SUMMARY REPORT - PRIMARY PLANT MAKE UP STORAGE TANK UPGRADE

SAN ONOFRE NUCLEAR GENERATING STATION

UNITS 2 AND 3

RESPONSE TO NRC QUESTIONS AND CONCERNS

Figure 5.8 Hoop Stress Distribution in the Tank Shell

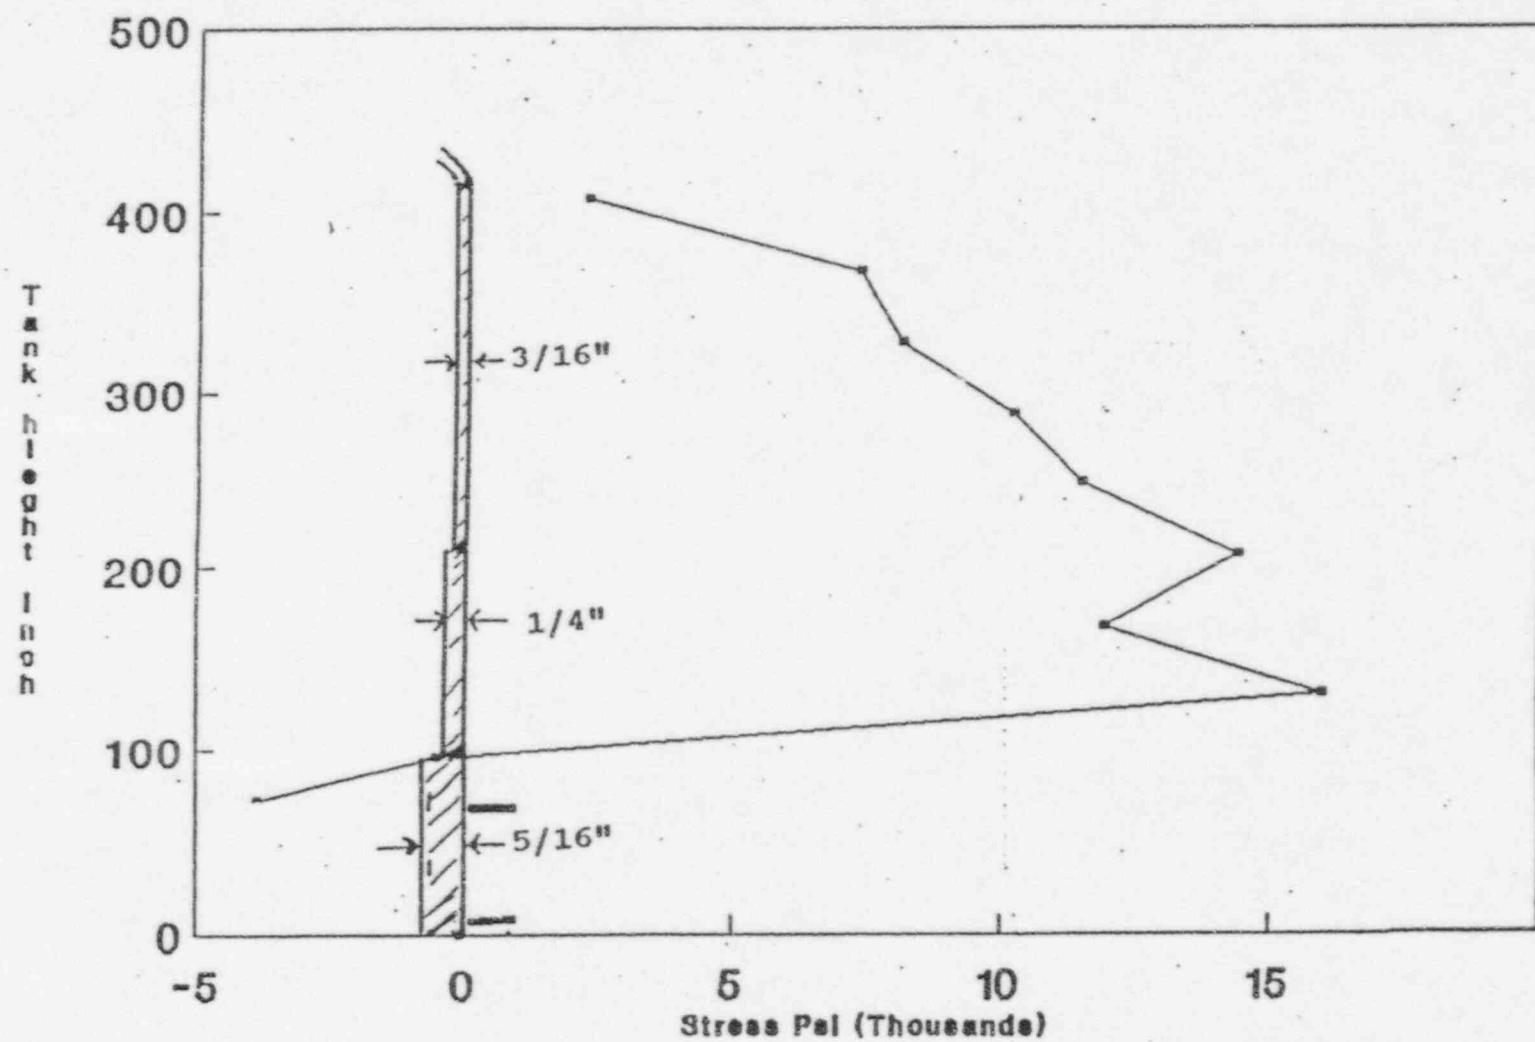
- (2) 8.1 STRESS CALCULATIONS, Sheet No. 277 - It was indicated that the loads, which produced the maximum hoop stress of 15.9 ksi from the tank FEM model, are the water sloshing SSE load and tank hydrostatic pressure. What about the inertia load of the tank itself under SSE loading? Provide a detailed definition and information about this water sloshing SSE load.

- (a) The hydrostatic pressure with the tank filled to its maximum capacity, and
- (b) The water sloshing component of 3.29 psi added to the hydrostatic pressure component. This value is based on DBE conditions.

See response to question number 3 above.

Figure 3 Hoop Stress Distribution in the Tank Shell

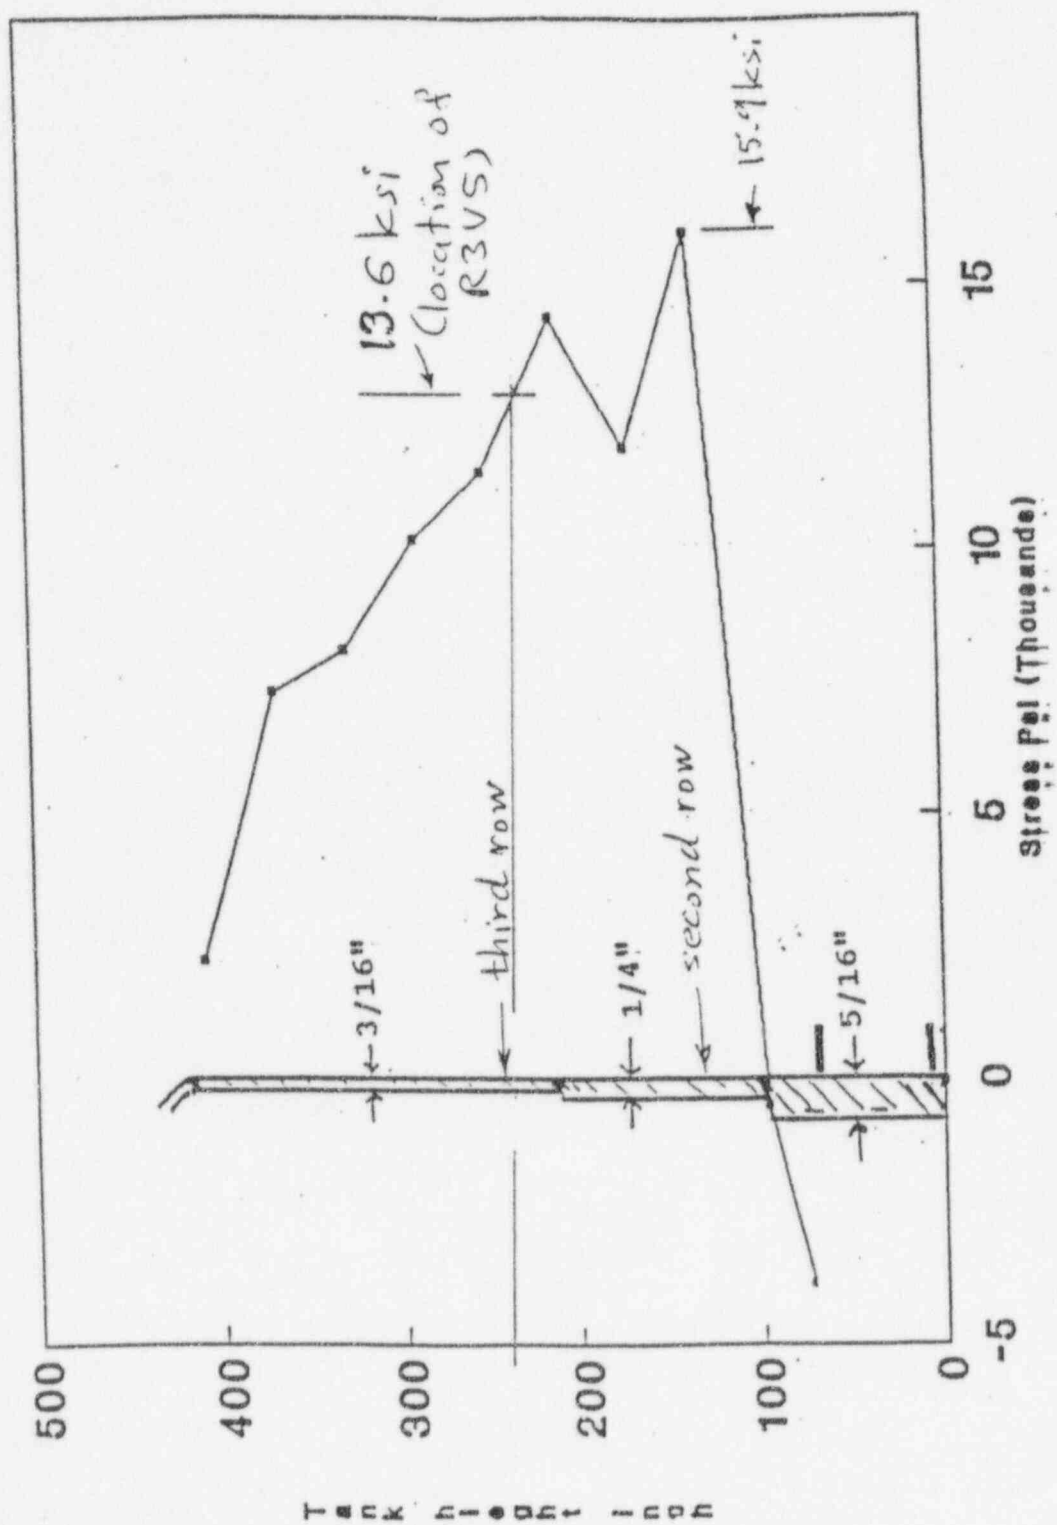
- (a) Flaw size = 3.5" representing the flaw with 95% confidence that 95% of the flaw population will be smaller. This flaw is conservatively evaluated as a vertical through wall crack subjected to the maximum faulted hoop stress in the tank of 15.9 ksi per Figure 3 (same as Figure 5.8 of Reference 1),
- (b) Horizontal flaw size = 4.875". This flaw size bounds all horizontal flaws in both tanks, and it will be evaluated using a through wall crack model and the maximum axial stress in the tank wall of 5.3 ksi per Reference 1,
- (c) Vertical flaw size = 4.375". This Unit-2 flaw is located in the third row as shown in Figure 1. Conservatively, a through wall crack model was used in

the fracture mechanics analysis. This crack is subjected to a hoop stress of 13.6 ksi at the crack location (see Figure 3). This flaw is bounding based on its size. The second largest vertical crack lies in the first row where the hoop stress is insignificant. Also, largest second row cracks are enveloped by case (a) above.
